Proposal for draft amendments to Regulation No. 37 (Filament lamps)

A. PROPOSAL FOR A CORRECTION TO ECE/TRANS/WP.29/GRE/2006/35

B. PROPOSAL FOR CORRECTIONS TO ECE/TRANS/WP.29/GRE/2007/13

Figure 1 - Main drawings"

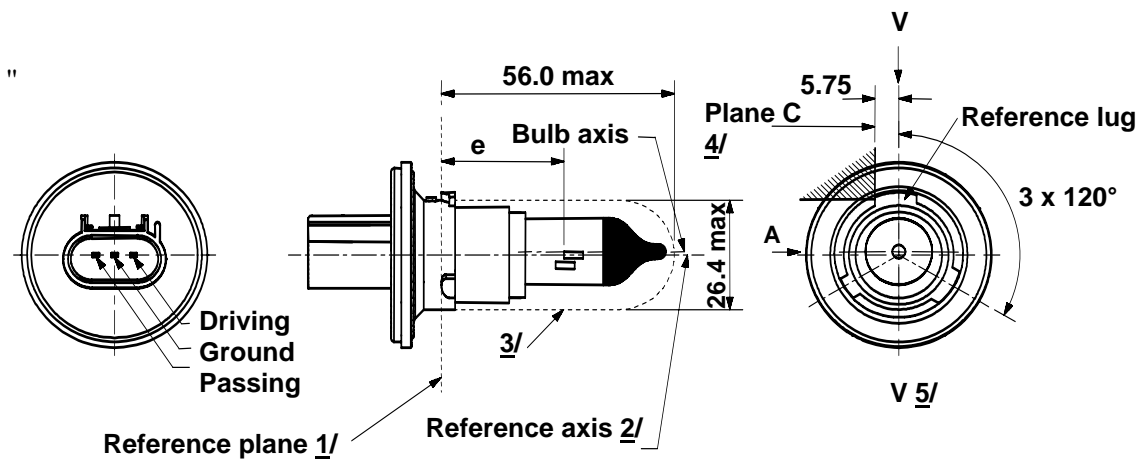
Page 3, sheet HS6/1, figure 1, correct to read:

IEC added additional keying options for future use of light sources using the same cap type.
